**The George Washington University
Square 103 - Phase 1 Design
Garage Base Building**

**REVISED FOGGY BOTTOM CAMPUS PLAN PUD
SECOND STAGE APPROVAL**

MAY 11, 2012

A1.R

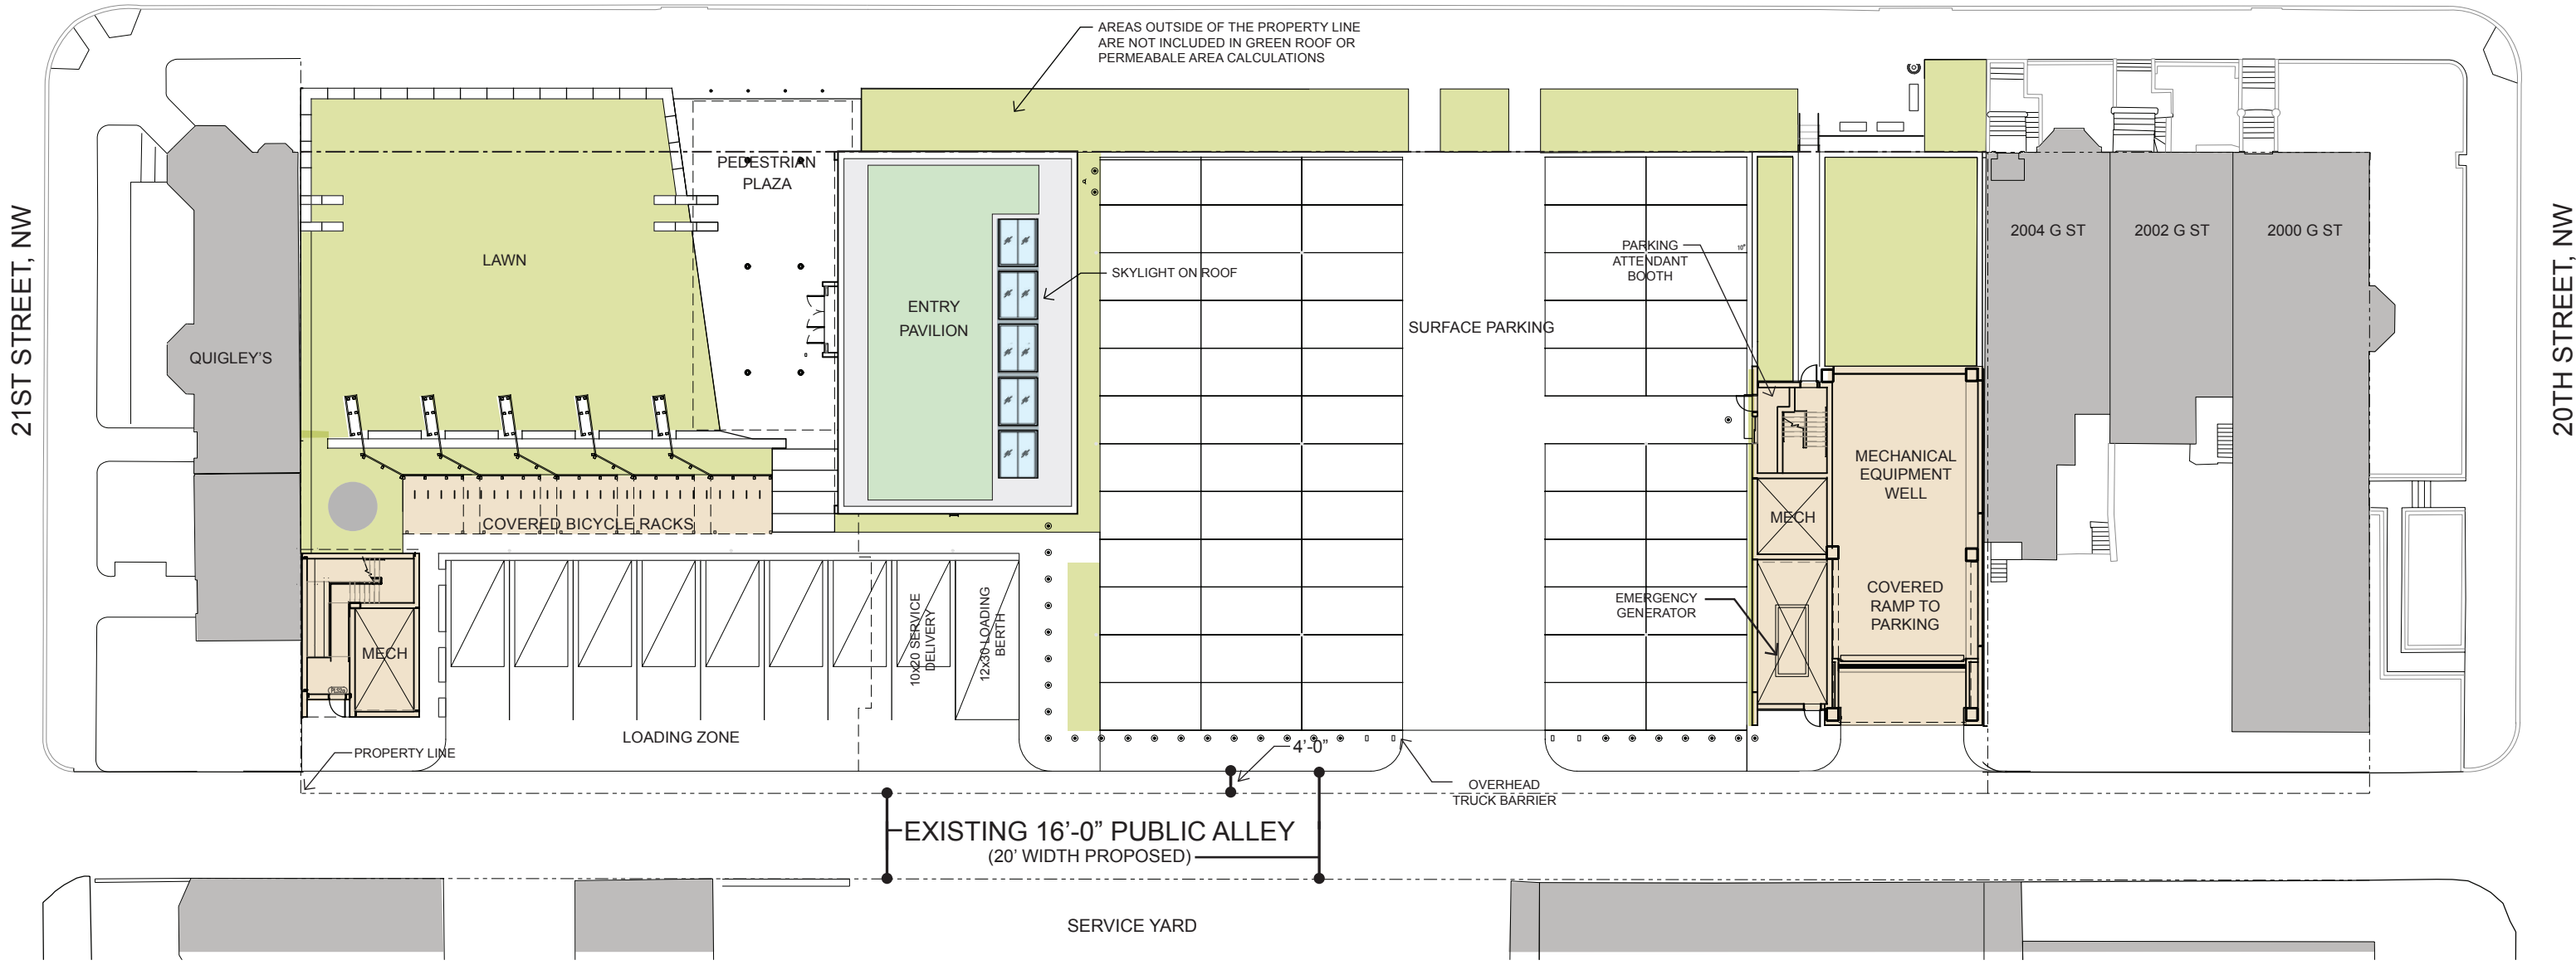
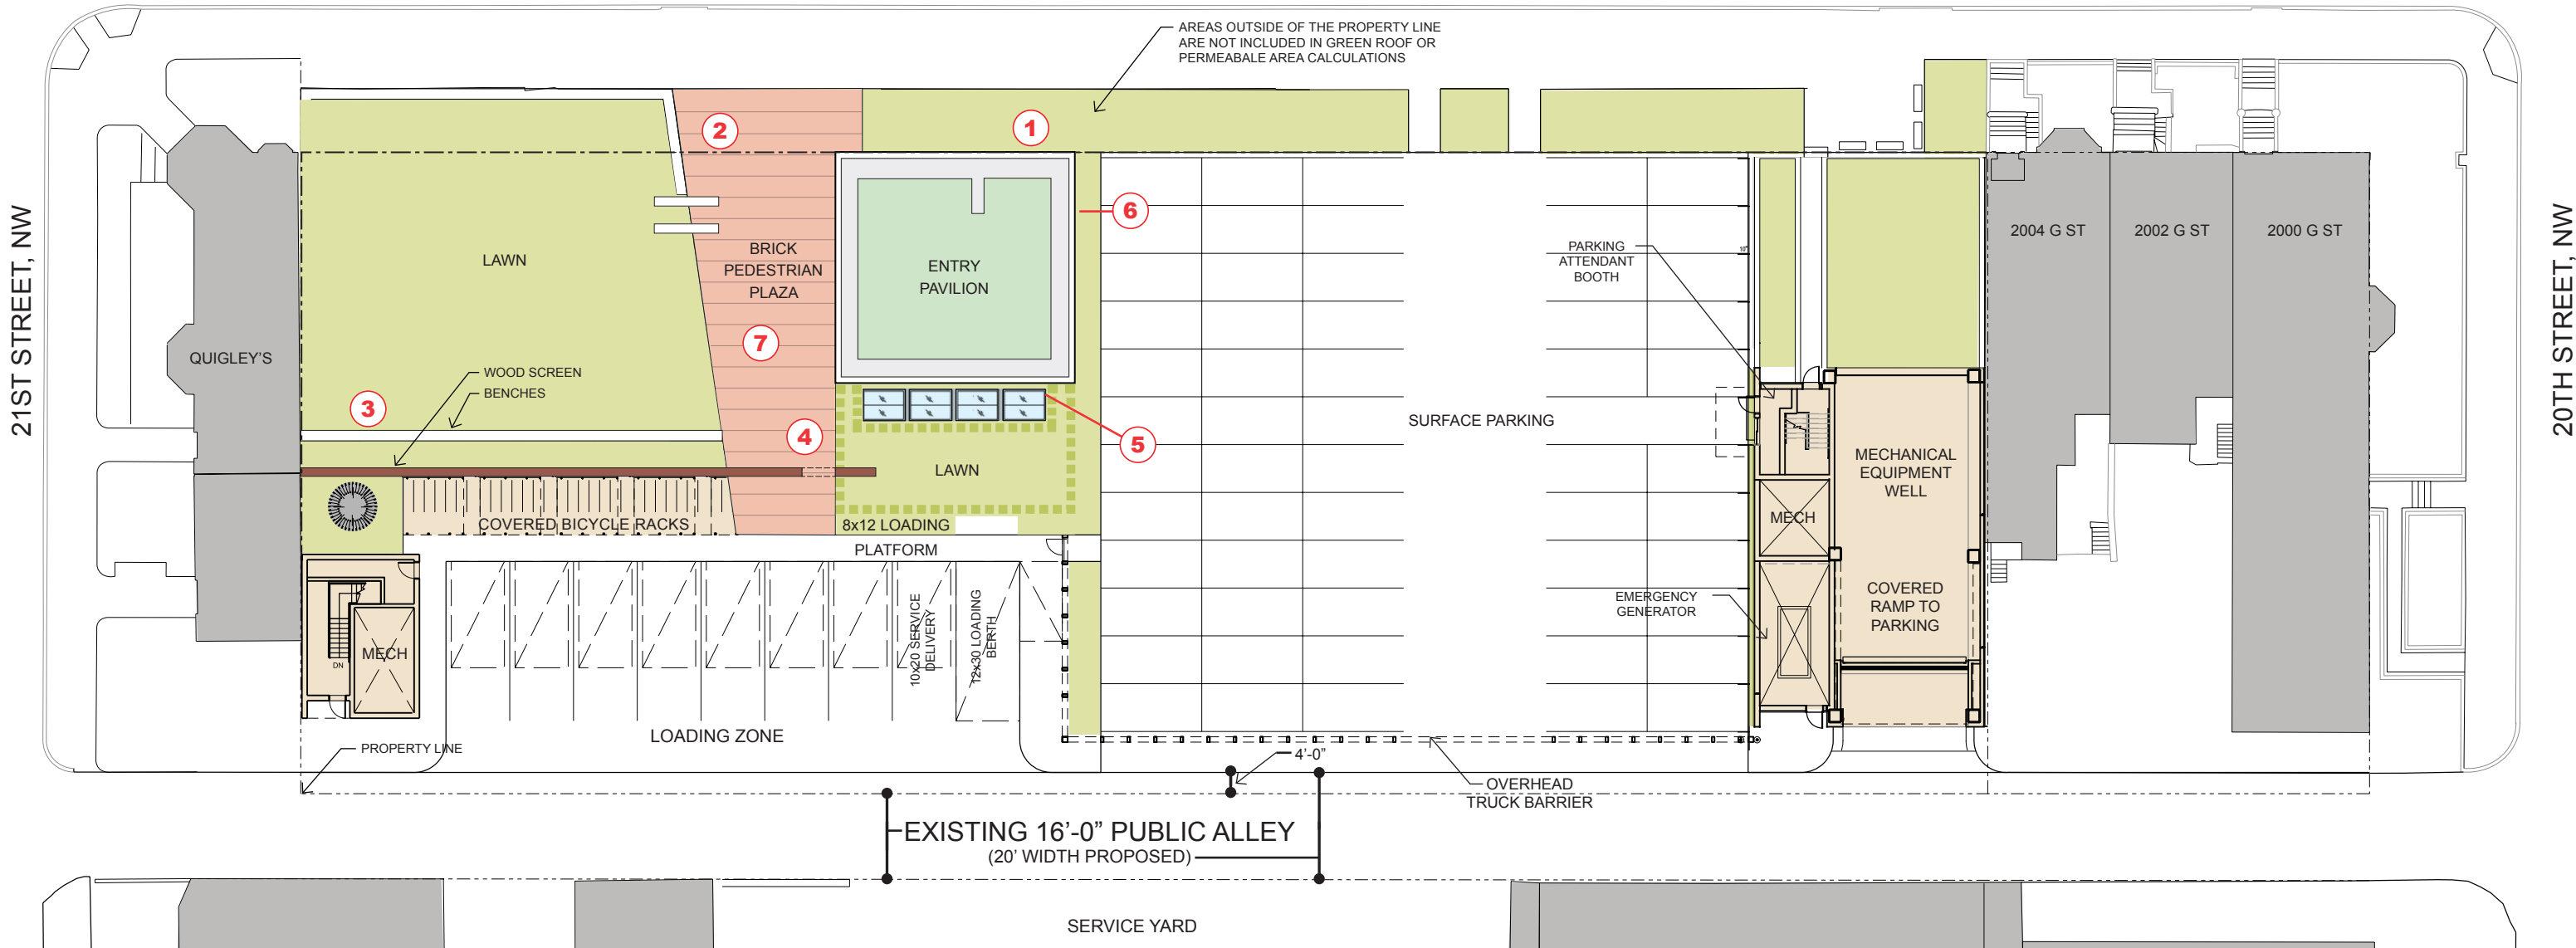
- KEYPLAN**
- 1. Reduce Pavilion length from 68'-0" to 43'-6"
 - 2. Change Pedestrian Plaza paving from granite to brick
 - 3. Simplify wood screen configuration
 - 4. Extend wood screen to East
 - 5. Skylights relocated to new lawn at grade
 - 6. Increase solid areas of facade
 - 7. Remove trellis
